**Public Hearing on Planned Unit Development
Rezoning and Site Plan—Restaurant
Depot—JRD Real Estate VI, LLC**

CITY OF LA VISTA
PLANNING DIVISION
RECOMMENDATION REPORT

CASE NUMBER: PPUD-17-0002

RE: Planned Unit Development (PUD) Rezoning and Site Plan – Initial Review
Lot 2 Harrison Hills
Restaurant Depot

SCHEMNER COMMENTS 3/29/17

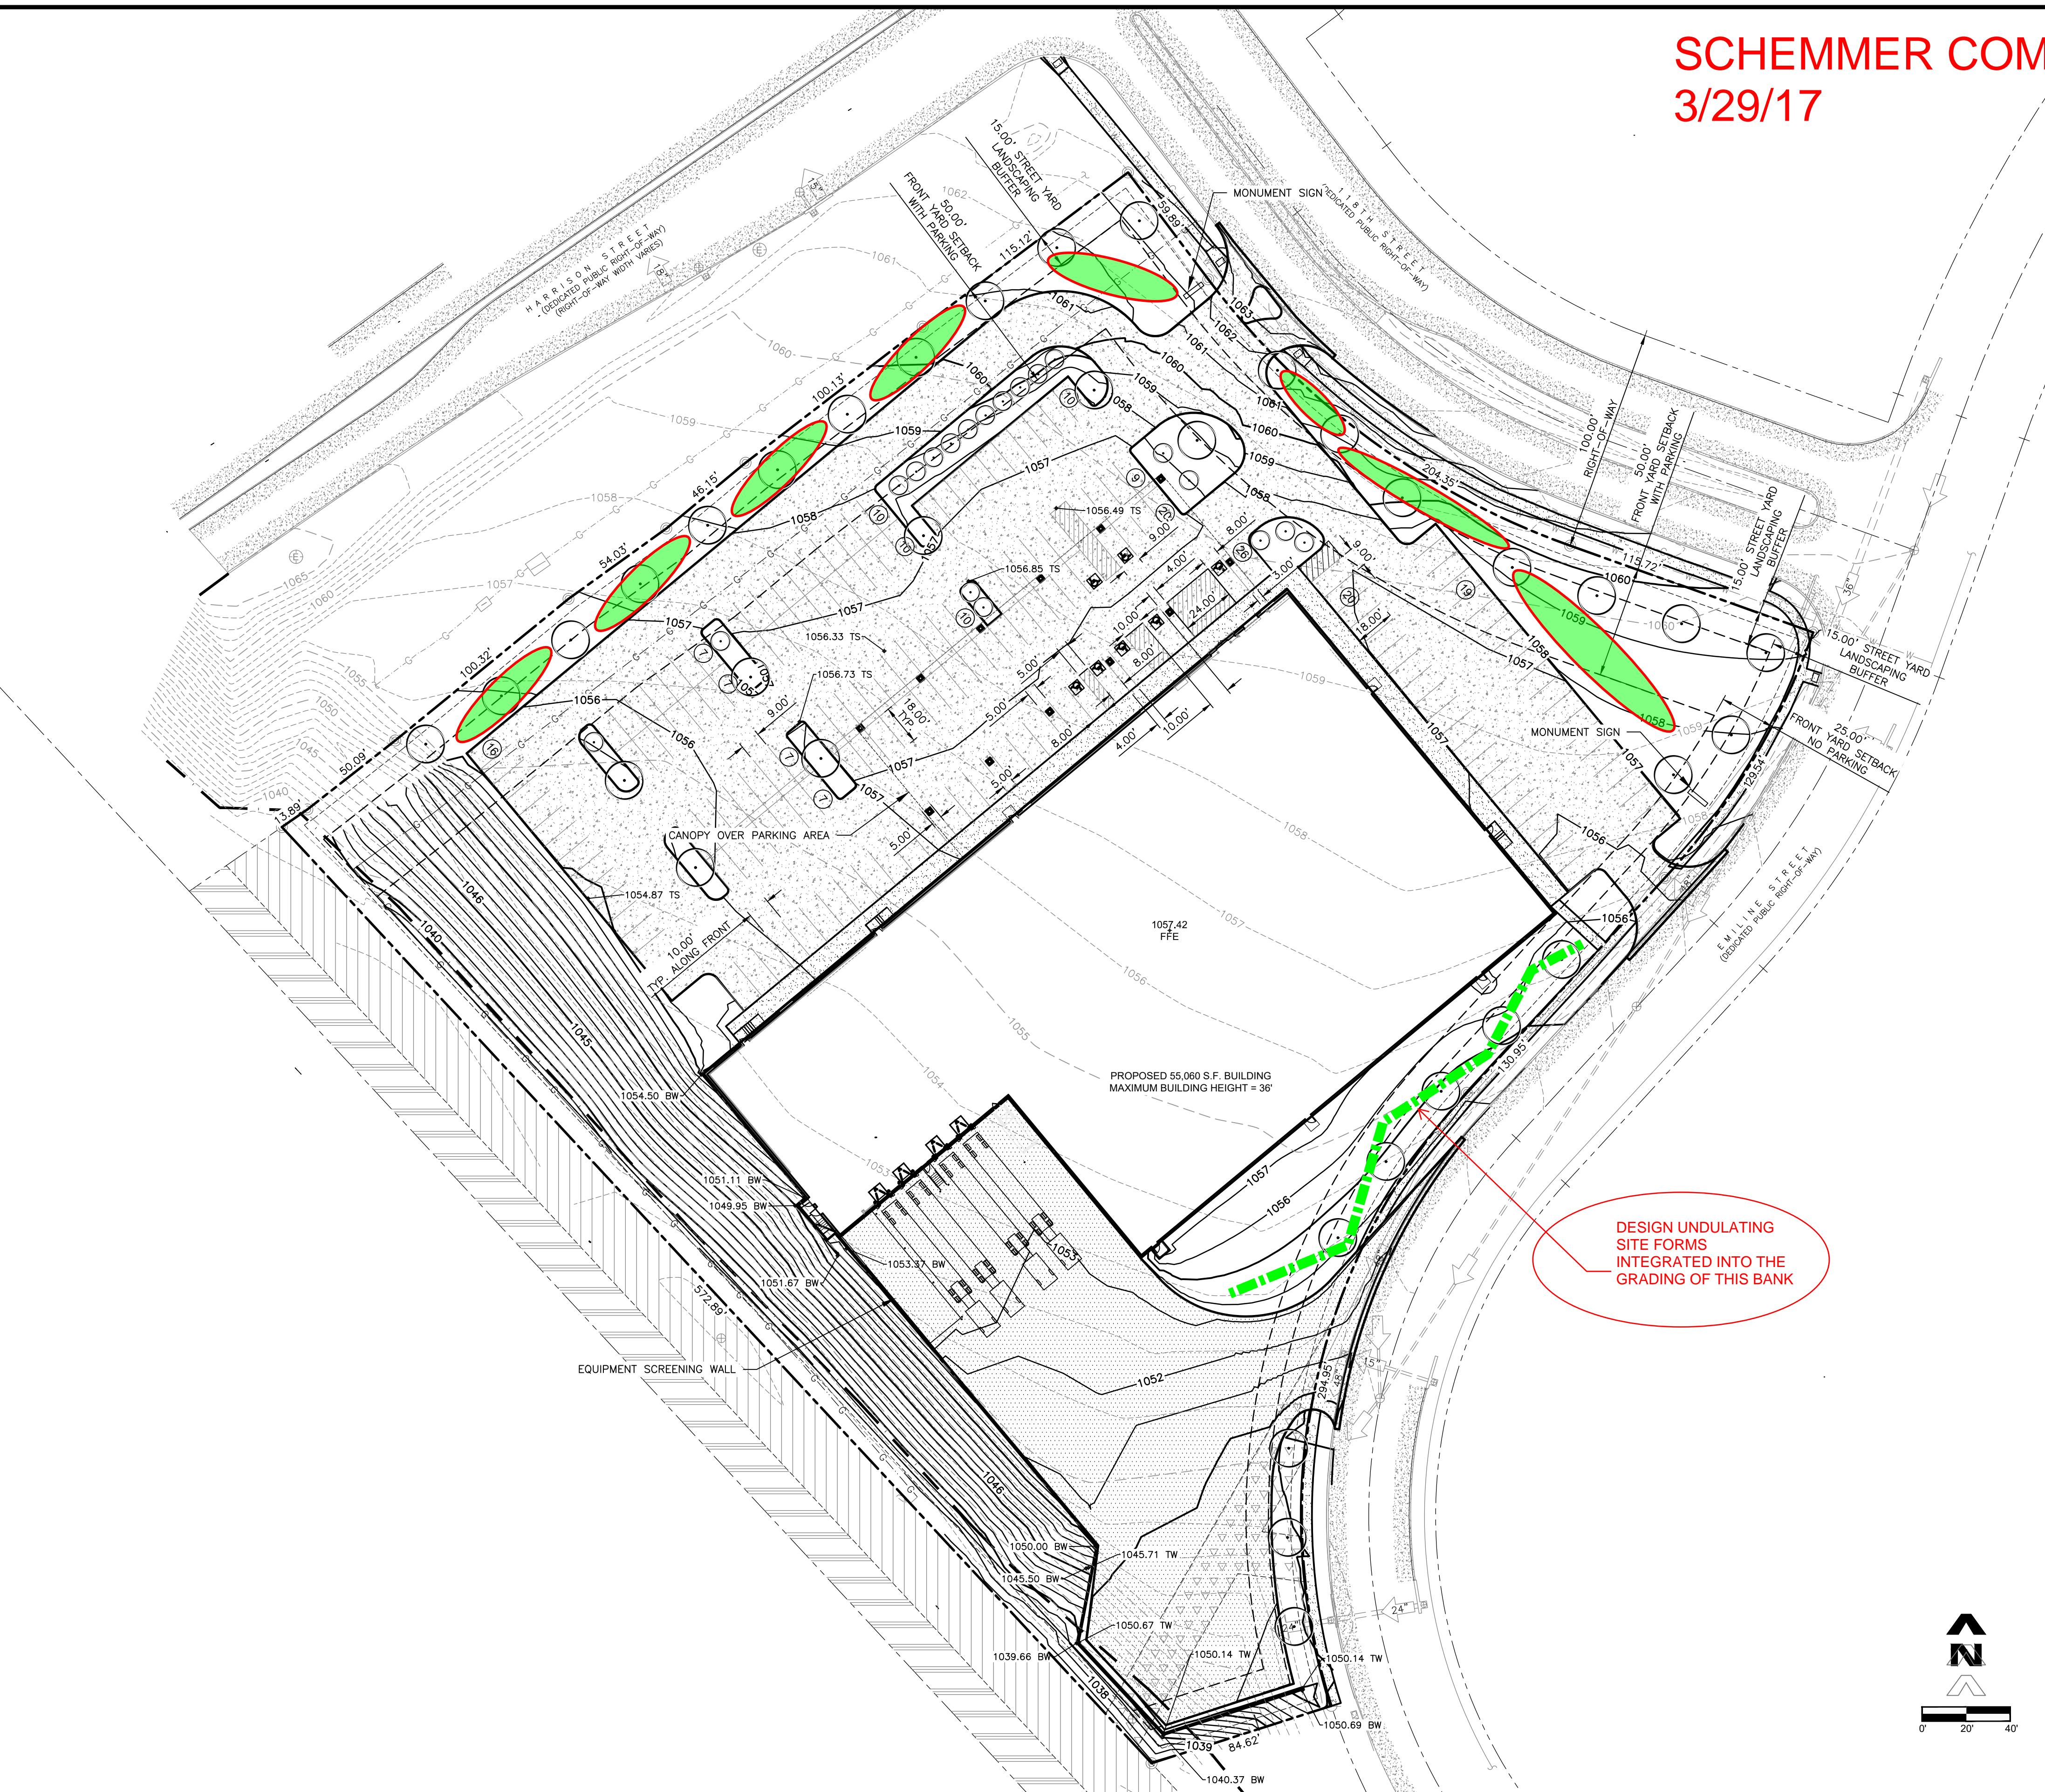
- 1) All proposed plant species and the required variety are consistent with the guidelines.
- 2) No natural, undulating site forms are indicated. My PDF sketch notes show some possible locations around the perimeter of the property.
- 3) The dock area should be better screened by coniferous trees to limit street views in summer and winter.
- 4) I don't see any site service equipment indicated yet (e.g. transformer) but those will need to be screened.

REVISIONS	DATE	03-03-17
1	JOB NO.	16356
2	PUD SITE PLAN	
3	SHEET NO.

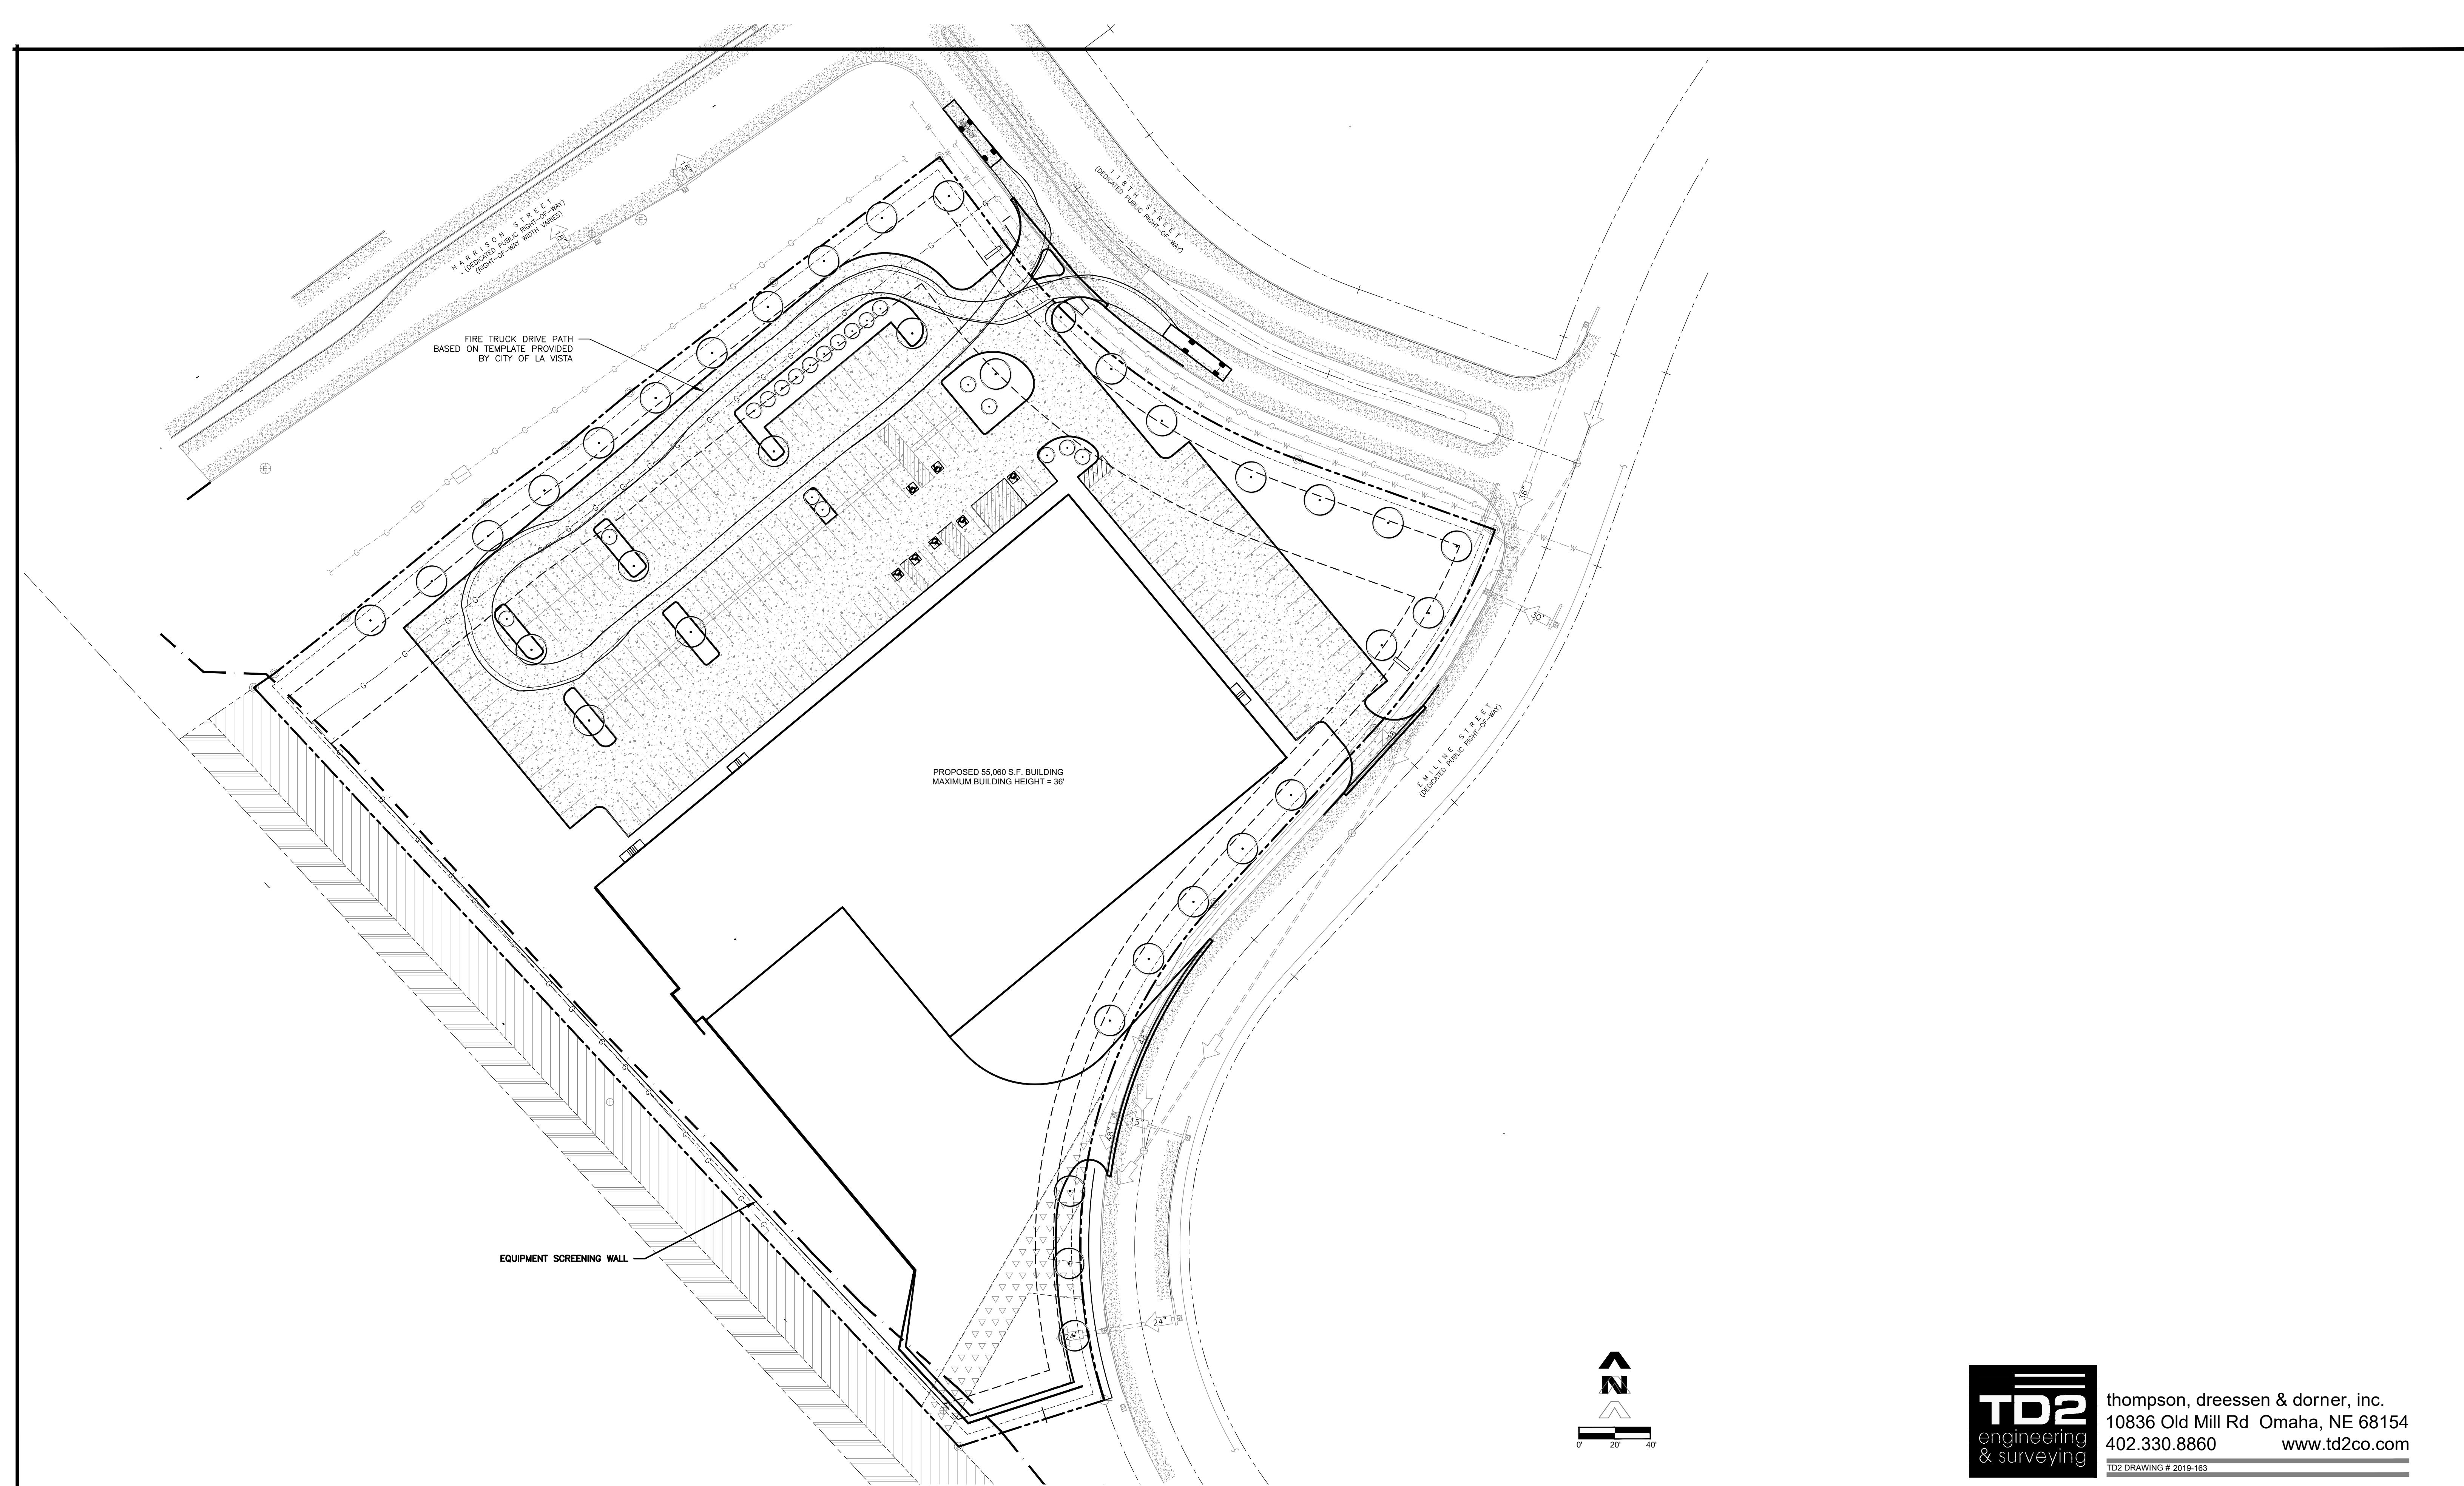
1. Article 5.15.04.01 requires the applicant to submit a proposed schedule of construction. This document was not provided in the application packet.
2. In regards to the considerations of Article 5.15.04.06 the proposed right-in/right-out access onto 118th Street needs to be revised to a right-in only access with appropriate on-site signage to indicate no exit at that location. The traffic study recommends providing “No U-Turn” signage at the intersection of 118th and Emiline to address the vehicles leaving via the 118th Street access. Drivers are unlikely to obey the prohibition because the alternative is inconvenient. If they do obey the No U-Turn sign, they will have to go through the apartment neighborhood to reach the intersection at 115th/116th and Harrison which is not signalized. The vast majority would be trying to turn left at this location to go back to I-80 or Harry Andersen. In fact, the traffic study shows only 7 to 11 existing vehicles using the 115th/116th intersection during peak hours to turn right to go eastbound. This would indicate either very little usage of the 118th Street right-out exit or else many U-turn movements. Other comments on the traffic study will be provided at the end of this letter.

5. The PUD Site Plan provides the locations of two proposed monument signs. Setbacks for these signs need to be dimensioned on the plan. The minimum setback for monument signs is 10 feet.

6. The proposed public sidewalks need to be 5 feet wide. A notation needs to be added to the PUD Site Plan.
7. In regards to Article 5.15.05.04, there is a statement on the PUD Site Plan about storm water management. This needs to acknowledge the criterion for no increase in the 2-year storm event peak flow between pre and post development conditions. A new storm sewer pipe to the West Papillion Creek has been indicated. At building permit time, this will need to be coordinated with the West Papillion Creek trail that is currently in design as the proposed pipe will have to cross that trail and cross property owned by the Papio-Missouri River Natural Resources District (former UPRR right of way). A Corps permit for discharge into the West Papillion Creek may also be needed. Staff recommends avoiding this new pipe to the West Papillion Creek if possible.

2. Right-In / Right-Out on 118th Street – We have modified our proposal to include a Right-In Only along 118th street. Supplemental on-site signage will be installed as required by the City of La Vista to indicate “no-exit” at this drive.

5. Monument Sign Setbacks – We have added the dimension(s) to our plans indicating compliance with the Setback Requirements.
6. Public Sidewalk Widths – The sidewalks have been dimensioned to be five-foot wide as required.

7. Strom Water Management – The SWM Statement has been updated to reflect the new plan for storm water and includes proper notes matching the City of La Vista requirements for peak storm events.
